Access Compliance Report

Public Rights-of-Way

(Curb Ramps)

| Intersection ID: 43869 | Main Street: CALDWELL RIDGE PY | Cross Street: SIDNEY CREST AV | Location: NE |

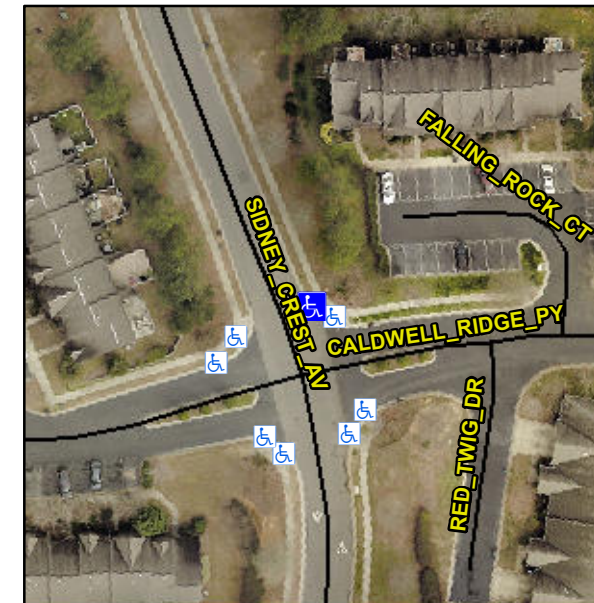
| ADA ID: 7AFA0E9BEFD5 | Ramp Type: Perp | Initial Pass/Fail: Fail | Overall Compliance: No |

Not Found, R304.5.1, R304.5.3

| Compliance | Description | Data | Compliance | Description | Data |
|------------|-----------------------|------|------------|-----------------------------|------|
| No | Ramp Width (in) | 40.0 | No | Ramp XSlope (%) | 8.2 |

Remove & Replace Entire Ramp.
